Model Royal 43 S

5:X 94.023-26

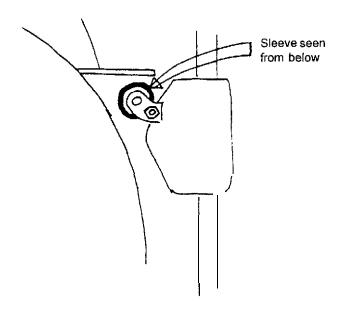
Some of the above named lawn mowers can lose their drive capacity due to the belt slipping. if this cannot be adjusted using the wire it can be due to adverse belt tolerances or the cutting deck. One way to increase the tensioning possibilities of the belt is to remove material from the sleeve around the gearbox's tensioning spring.

Proceed as follows:

- Empty the oil and fuel.
- Remove the belt and belt pulley.
- Loosen the wire from the gearbox and remove the spring.
- Remove the rear wheel suspension (it is best to remove the bearing cover and then fold back the rear wheel suspension to avoid replacing the start lock washer on the height adjustment stay).
- Cut approx. 3 cm off the sleeve (chisel, sharp knife or any other tool can be used).
 Reassemble
